STAFF RECOMMENDATION
404 South 16th Street
November 19, 2014

Application: New construction-infill
District: Lockeland Springs-East End Neighborhood Conservation Zoning Overlay
Council District: 06
Map and Parcel Number: 08313048300
Applicant: Lynn Taylor, designer
Project Lead: Robin Zeigler, robin.zeigler@nashville.gov

SITE PLAN

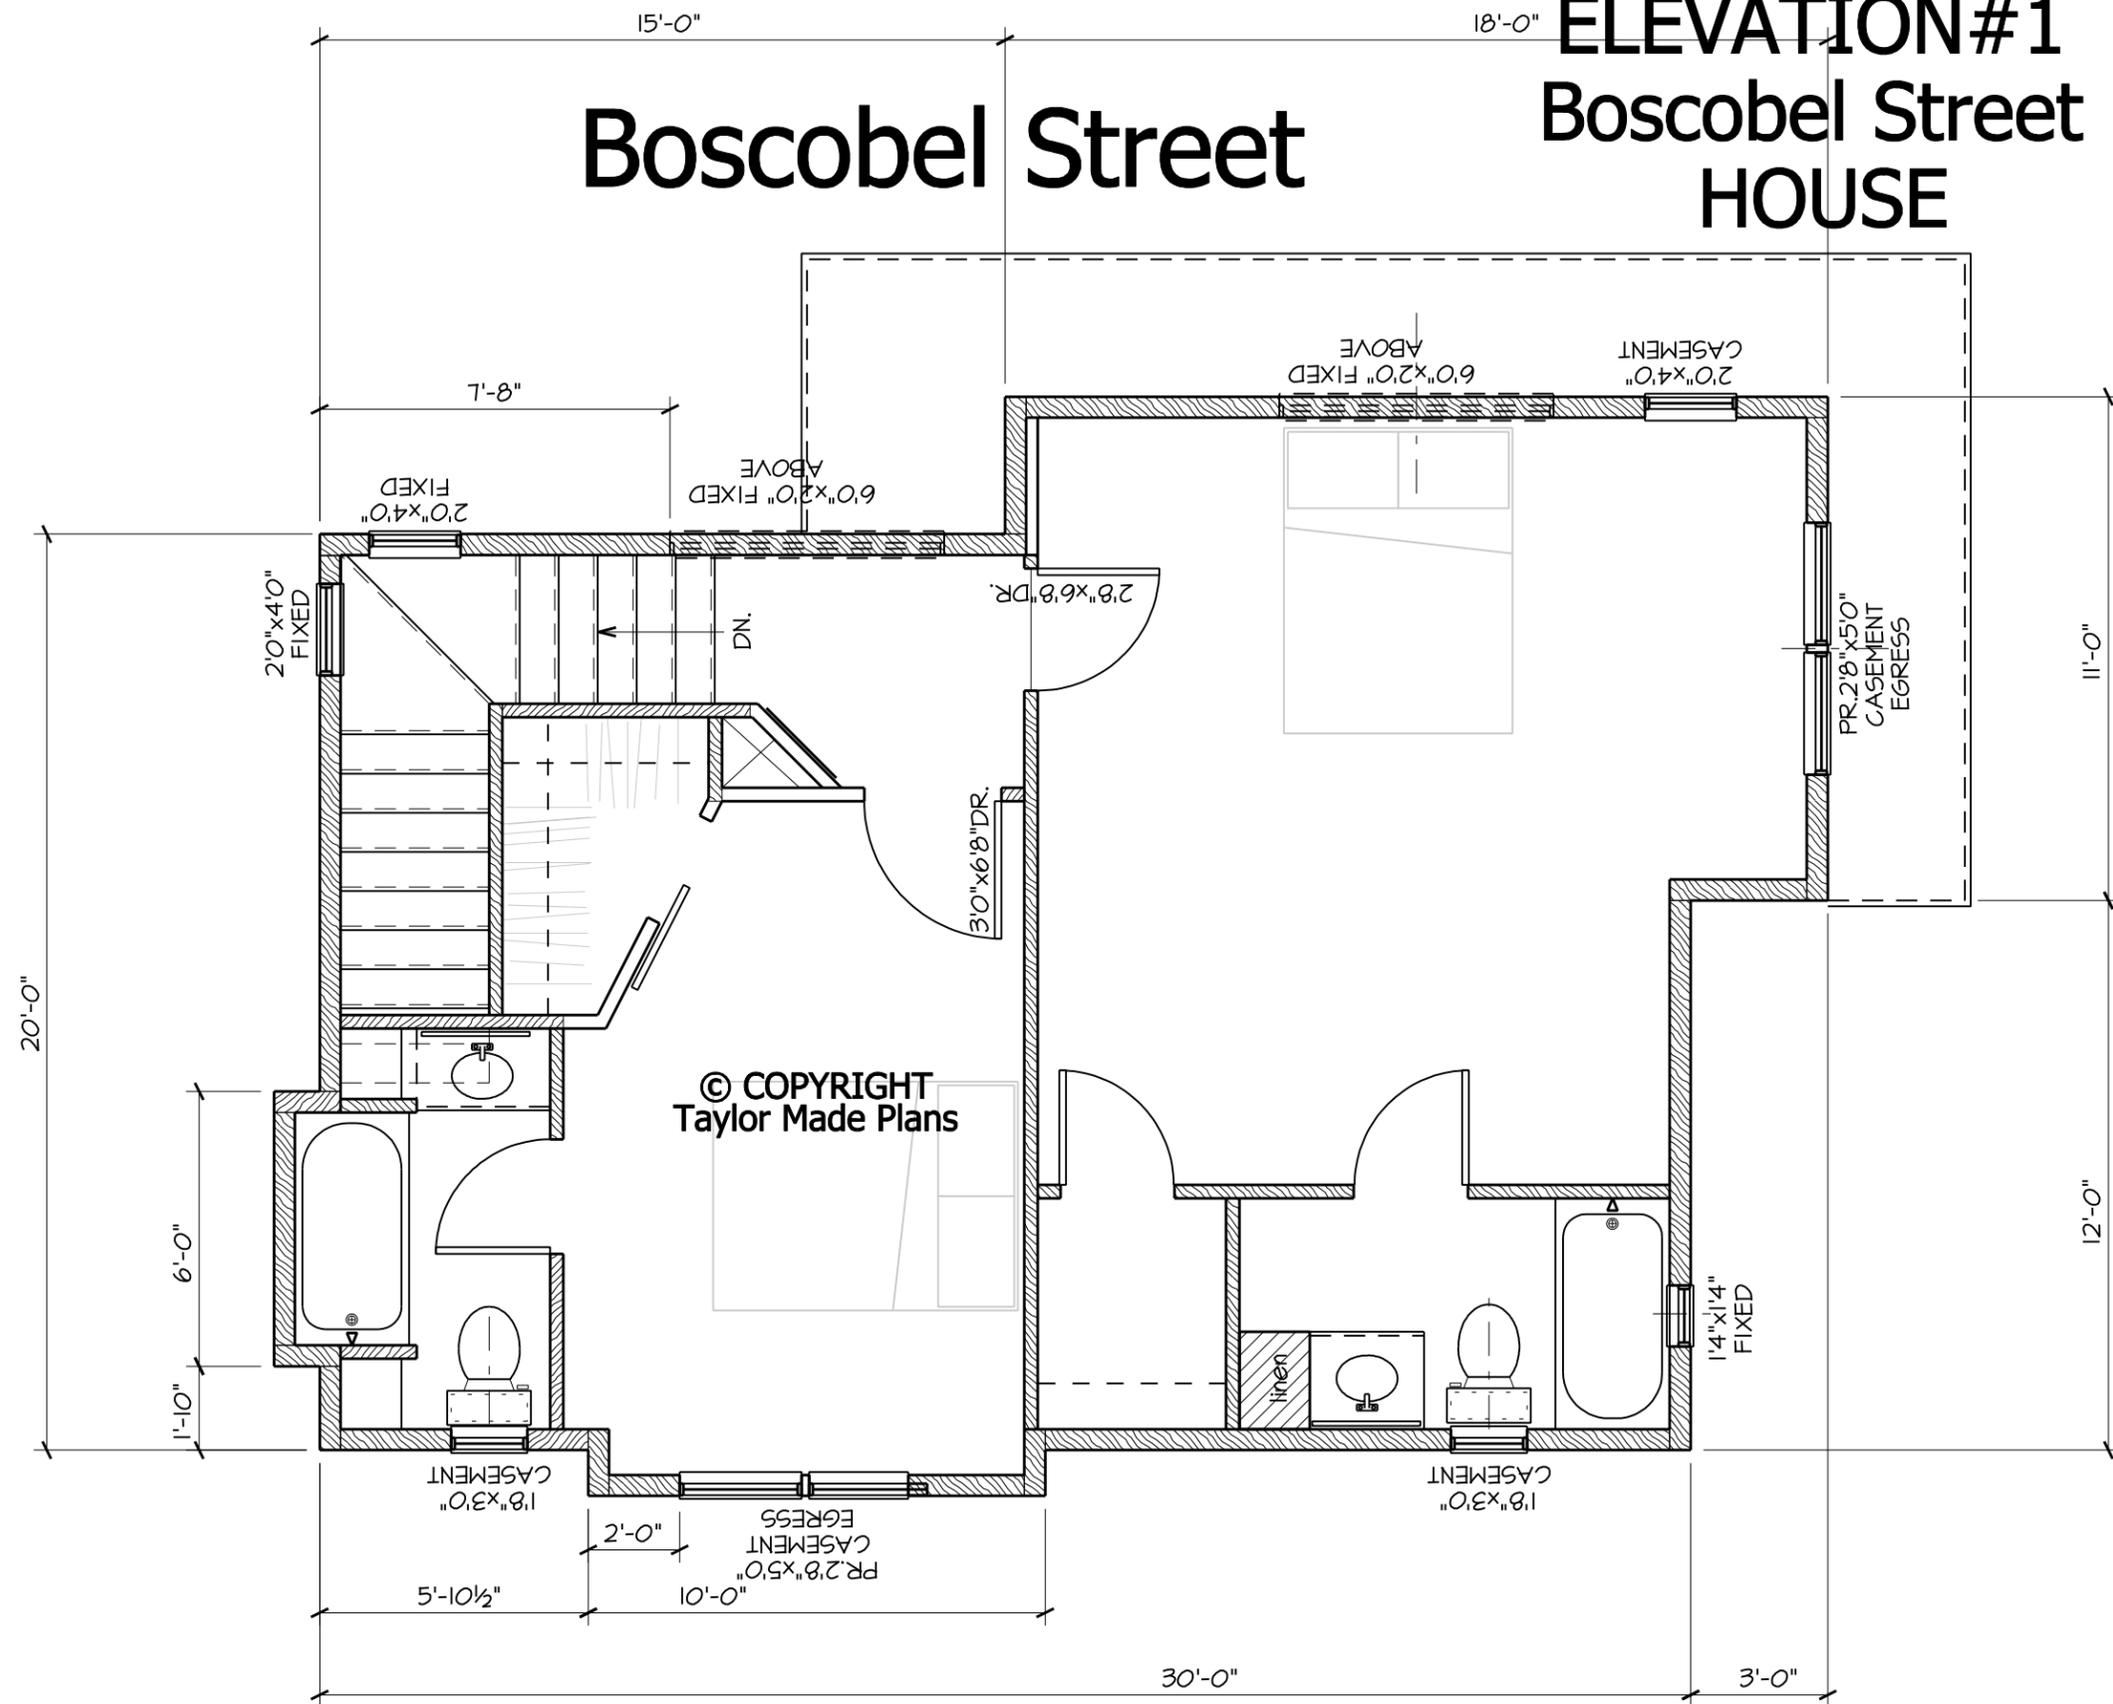
The alley house shows a wrap-around porch on the first floor plan and the site plan but not on the elevations. Staff recommends the drawings be revised so that they are consistent, prior to the issuance of the permit.

FRONT ELEVATION

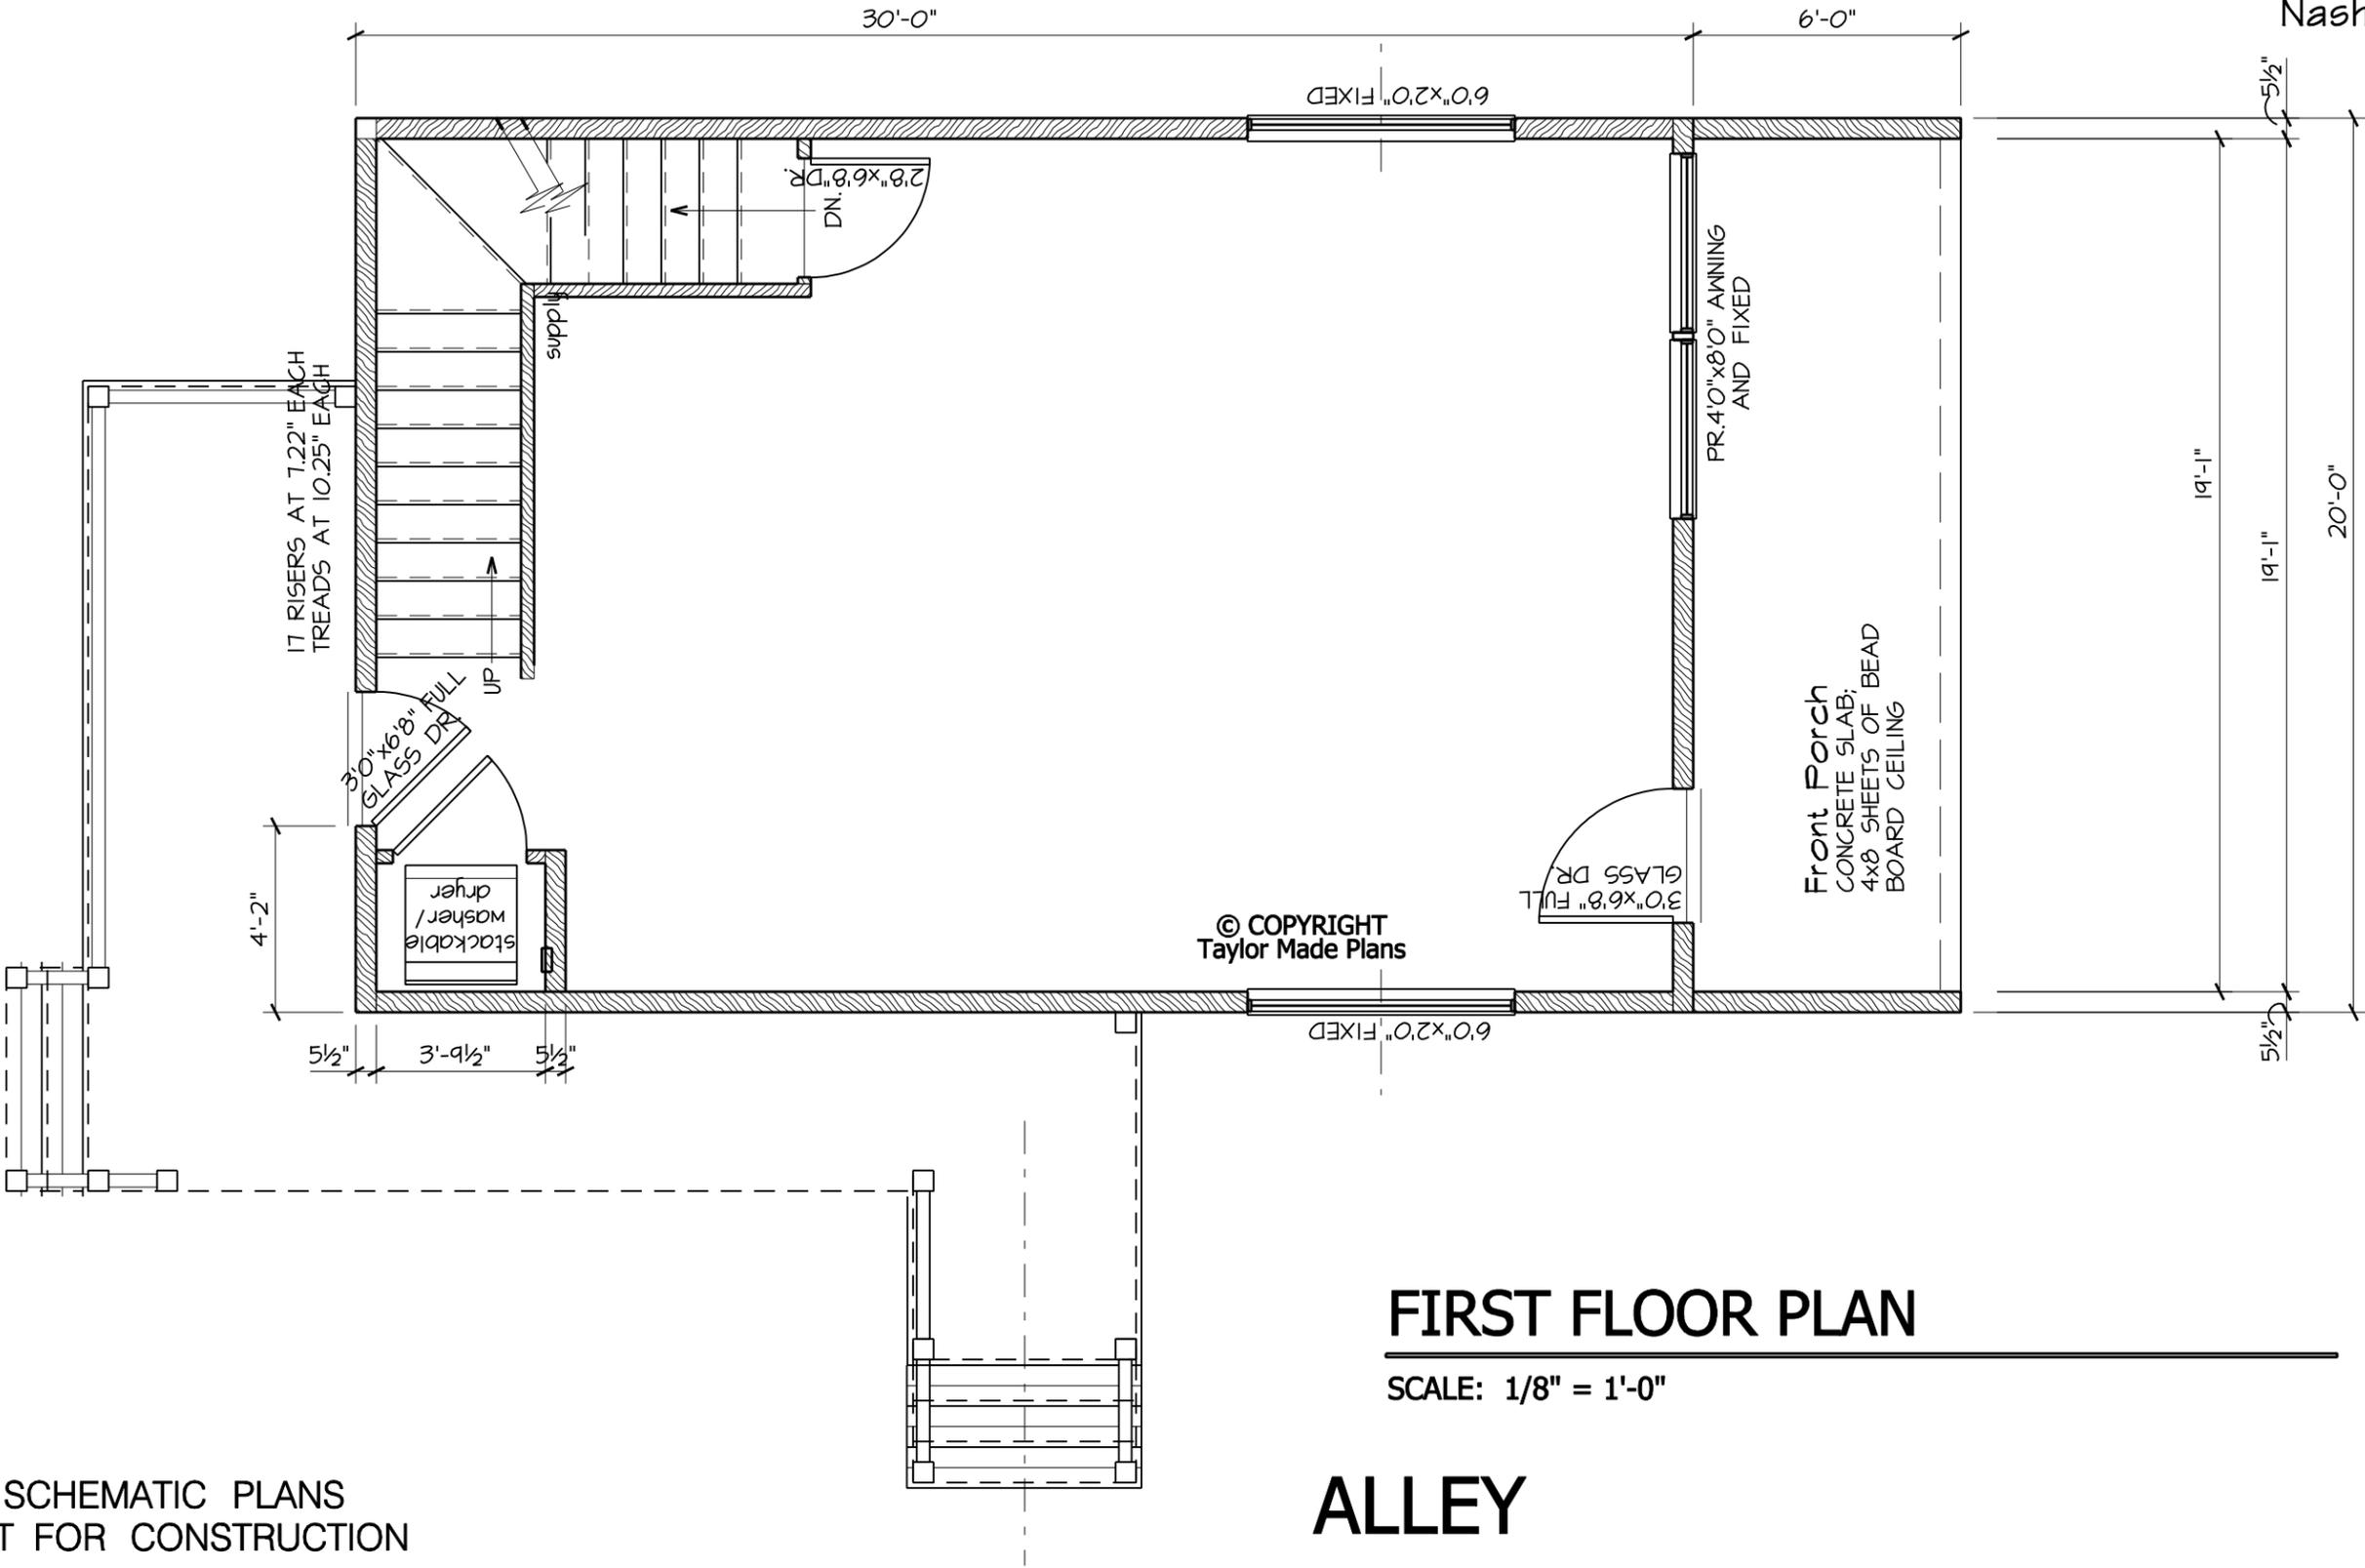
Proportion and Rhythm of Openings: Many windows on the proposed addition are all generally twice as tall as they are wide, thereby meeting the historic proportions of openings but not all. Staff recommends that all horizontal windows on the front of each building have a more vertical orientation. There are no large expanses of wall space without a window or door opening. Staff finds the project's proportion and rhythm of openings to meet Section II.B.7.
